**CHANGE ORDER APPROVAL FORM**

PROJECT: Construction Contract for Citrona Drive from Hickory St. to Beech St

CHANGE ORDER NUMBER: 1

**Description:** On June 26, 2023, the contractor poured the drop curb for the CR-L ADA ramp on the NW corner of Citrona Drive and Hickory Street. Once the drop curb was poured to match the layout shown on plan sheet 9 of the roadway plans, following the requirements of the FDOT Standard Plans Index 522-002, option B, the inspector realized that the existing special emphasis crosswalk did not line up. Since the existing crosswalk was shown in the plans to remain, the curb ramp would need to be extended to line up with the crosswalk per ADA requirements.

Attachment A

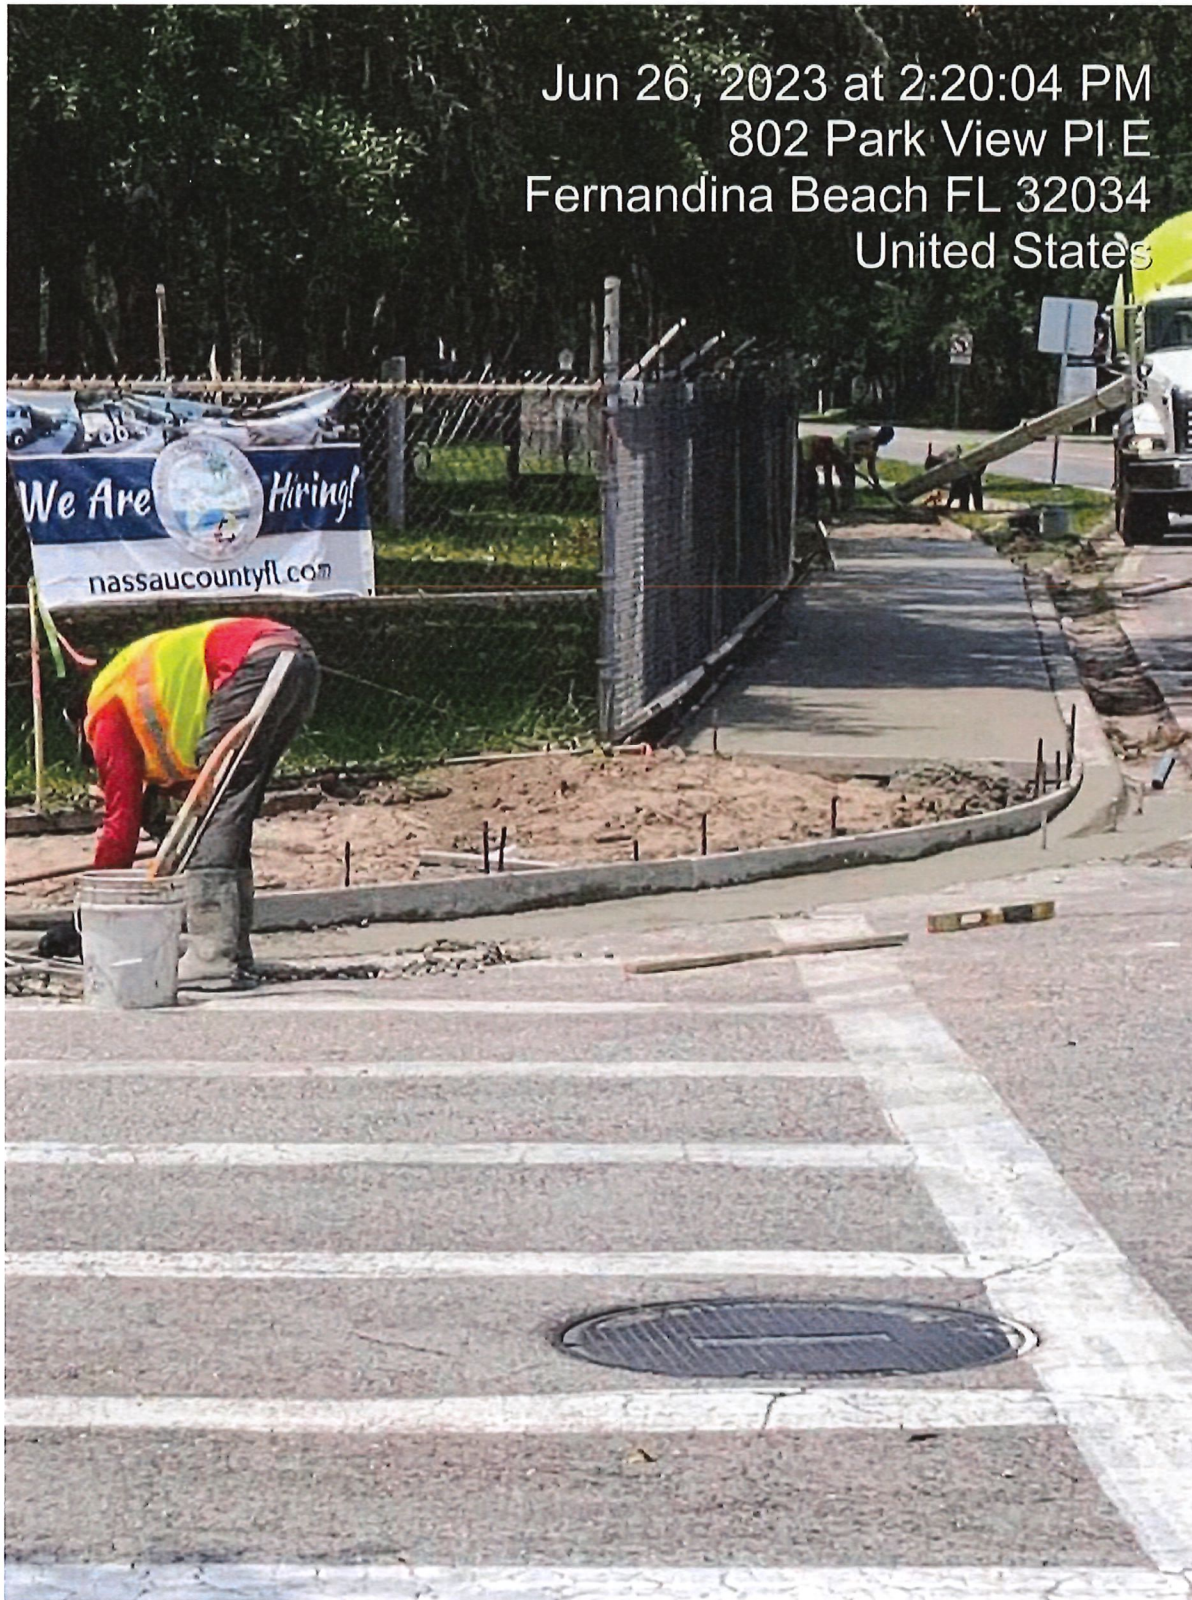
Arne you need to get with the EOR the existing cross walk does not line up with new ADA Ramp.

SHEET NO.	9
PLAN SHEETS 2/19/2022 12:09:59 PM SCS, CORP.

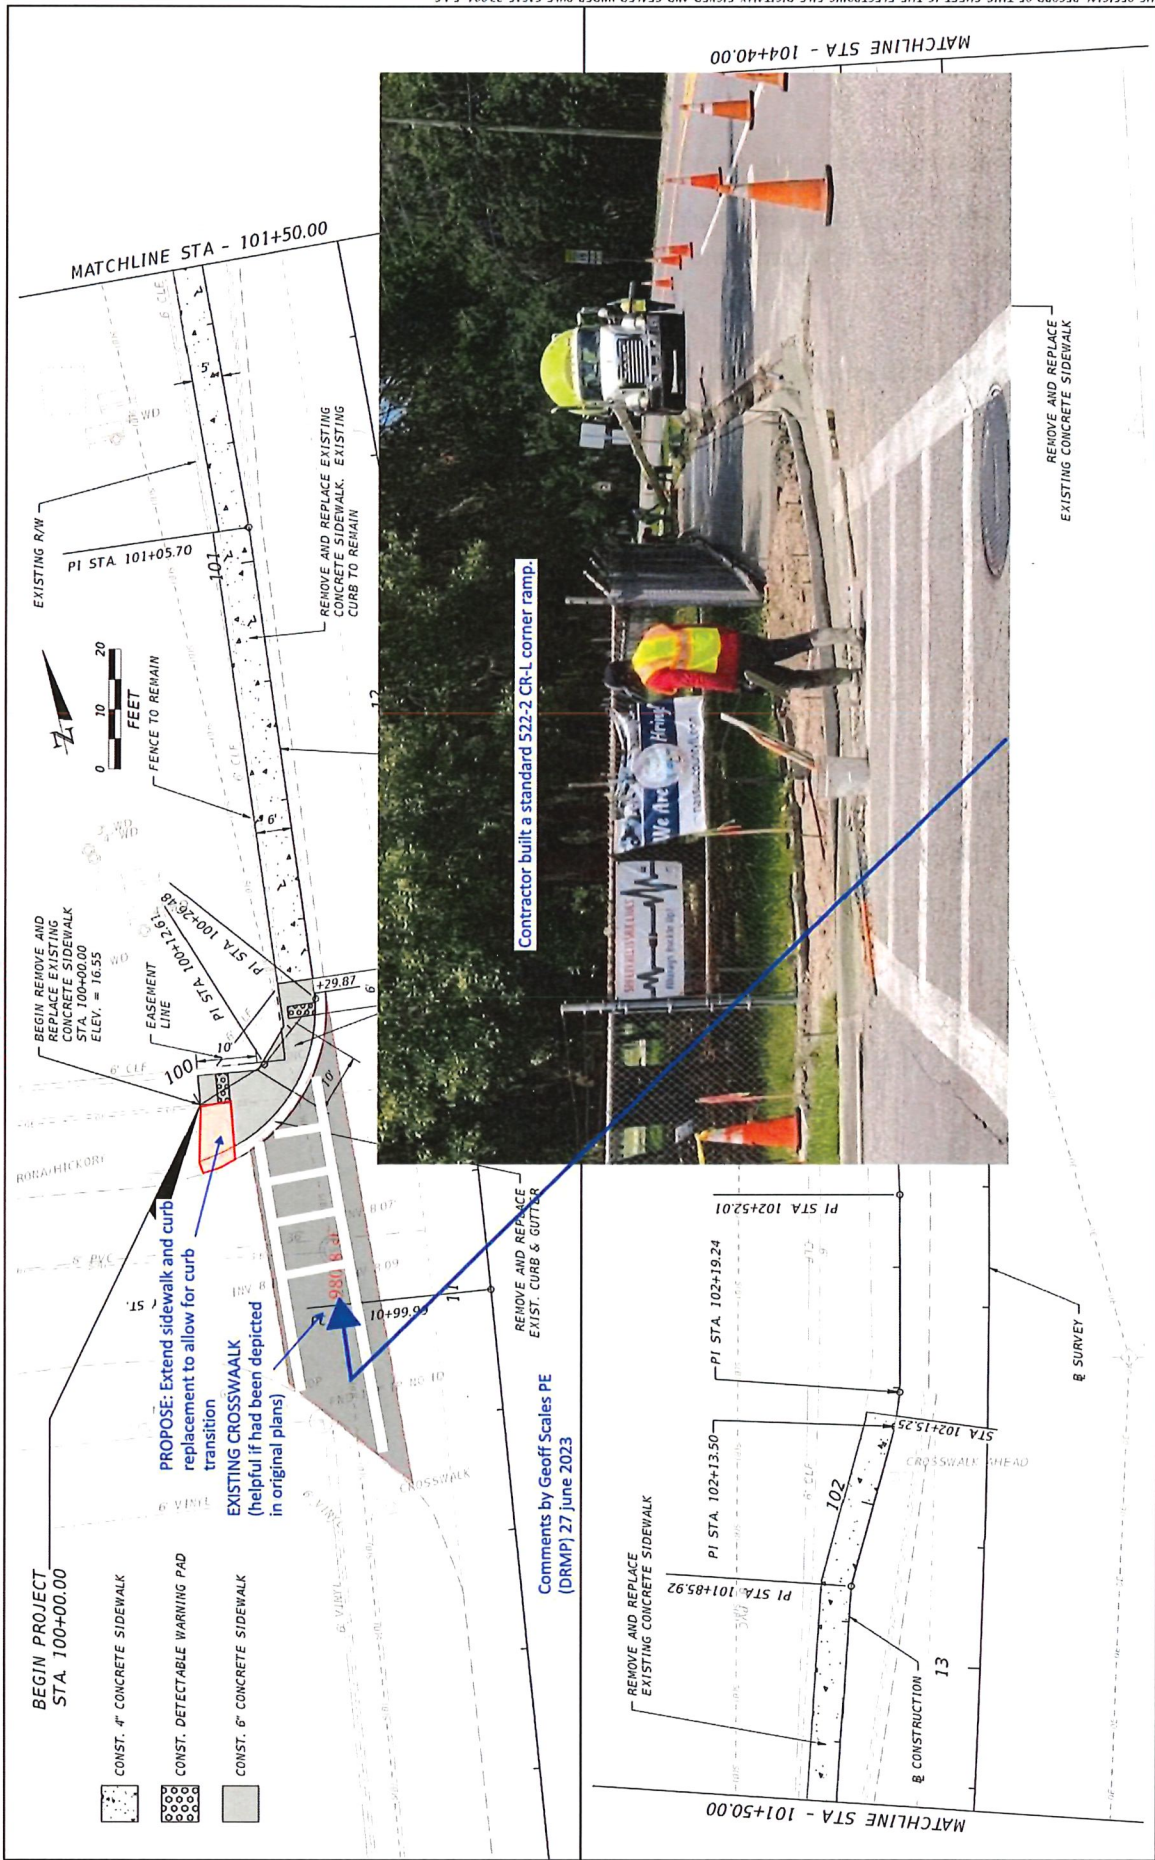
Per our phone conversation earlier this afternoon, I reviewed the plans, sheet 9, and the FDOT Standard Plans, Index 522-002, with the field inspector. The Contractor, CGC, built (the curb section of) a CR-L Ramp, option B, in conformance with 522-002 as modified by the plans, but there was insufficient room for the curb transition-to-drop section that will align with the existing cross walk.

If we are to preserve the cross walk, a short section of curb that was placed yesterday on the N.W. corner of Citrona Dr. and Hickory St. will need to be removed, along with a small additional piece of existing curb. See below and attached. This allows for the drop curb transition to be moved further toward Hickory St., and will slightly increase the curb and sidewalk pay quantities. In addition, the contractor will likely look for some compensation for the piece of new transition poured and subsequently removed.

The alternative would be to remove the cross walk by grinding and re-striping, but this may lead to ADA best practice violation (not parallel to major street).

*"In order to preserve the existing crosswalk, the County requests that you remove a portion of transition curb previously placed, and extend the curb and new sidewalk as shown in the attached."*

Attachment C

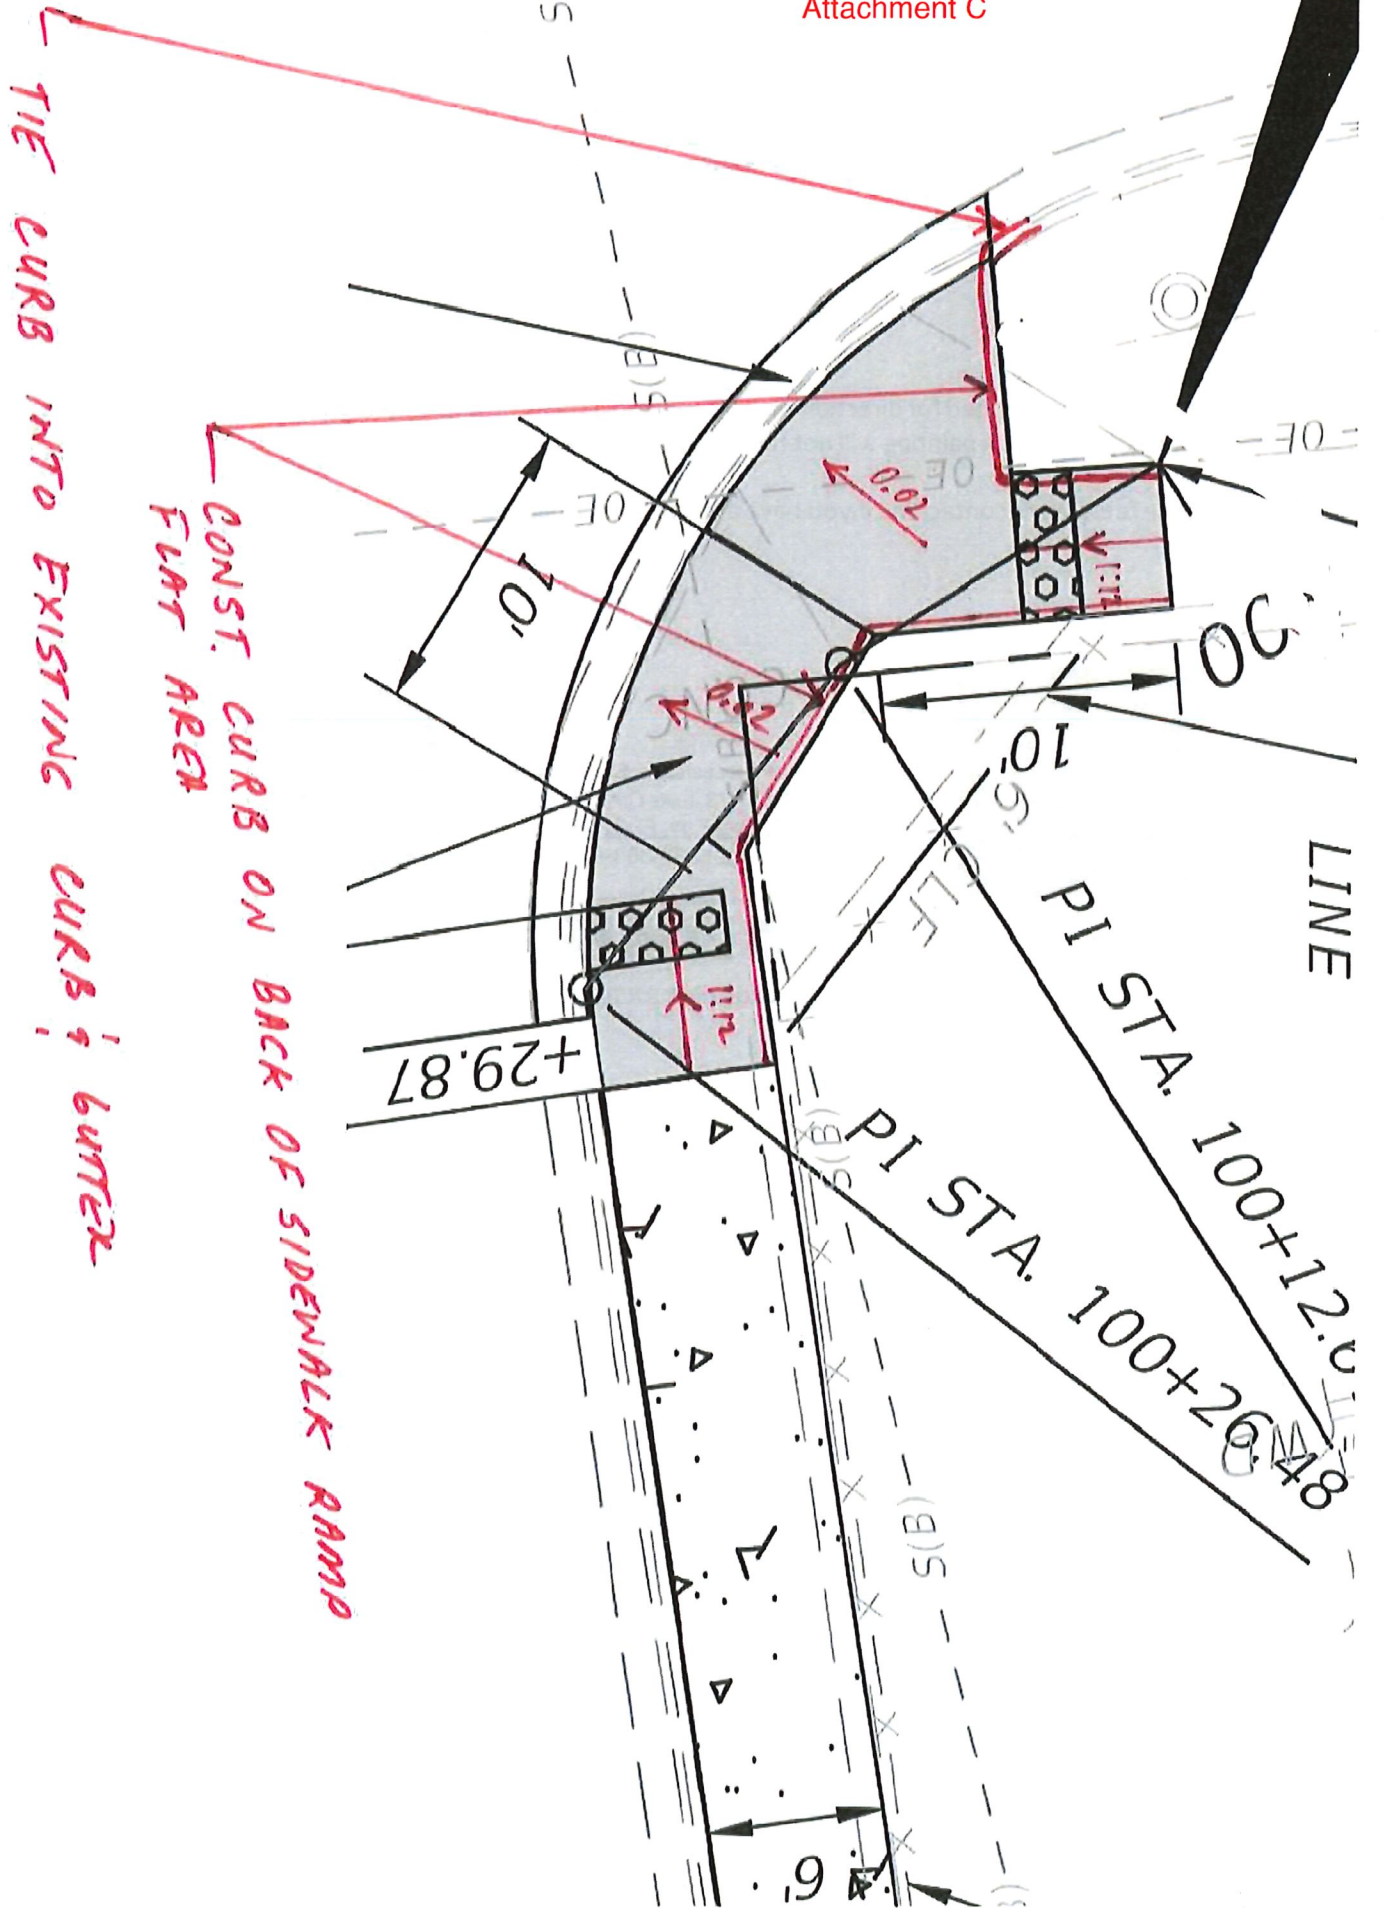
Please see the attached for direction on how to handle the drop curb situation. The existing special emphasis cross-walk painting will not need to be relocated.

Attachment D

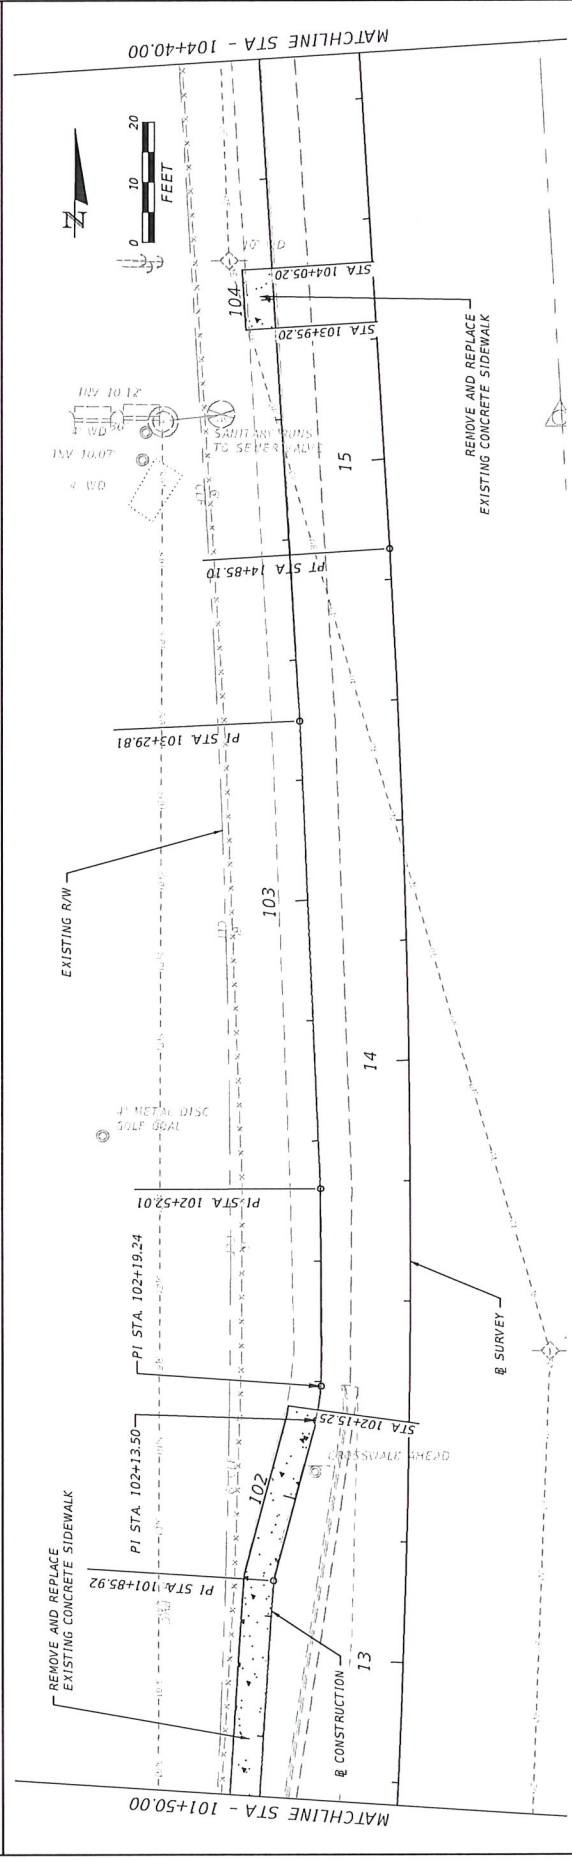
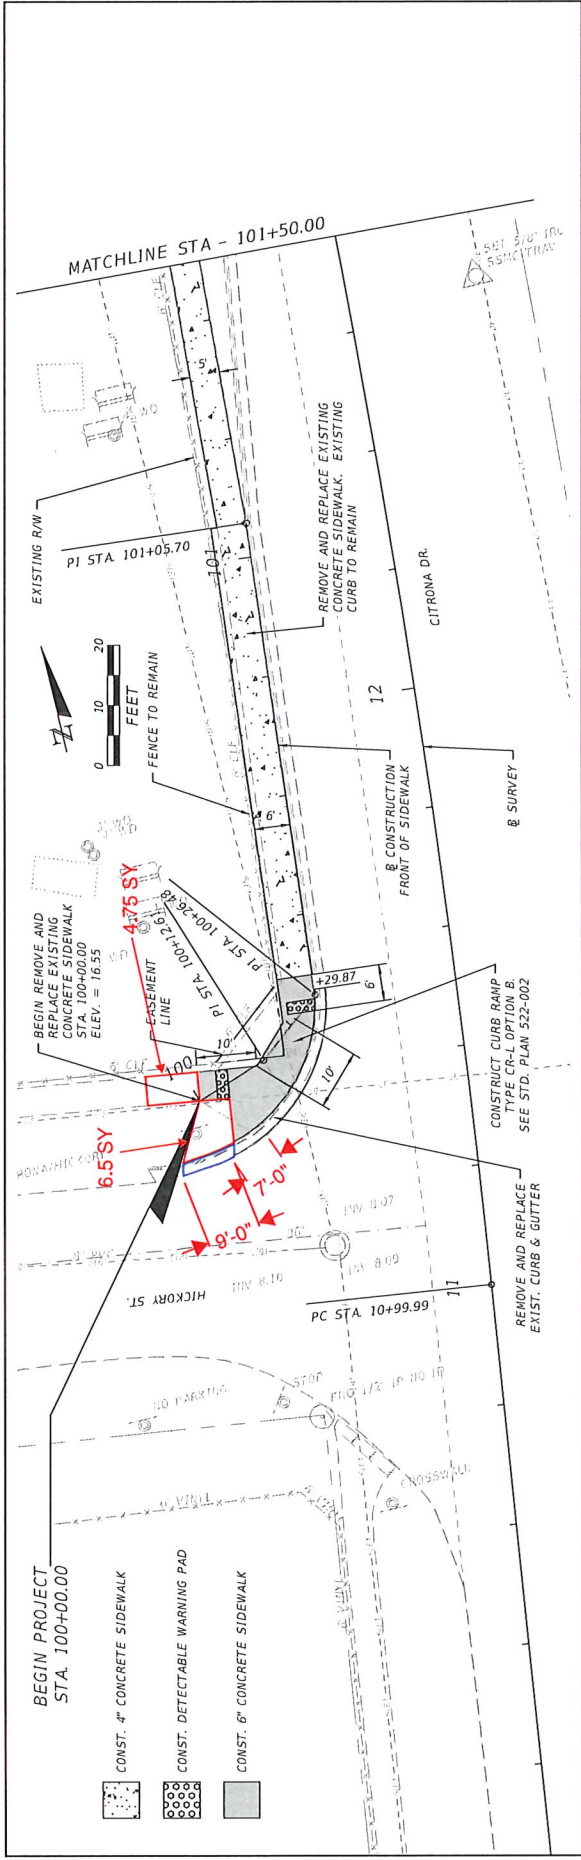
Arne, please see the attached drawing depicting additional work done at the Hickory Street corner.

- Additional 6" SW – 12 SY
- Additional Concrete Removal: 8 SY
- Additional F Curb – 16 LF
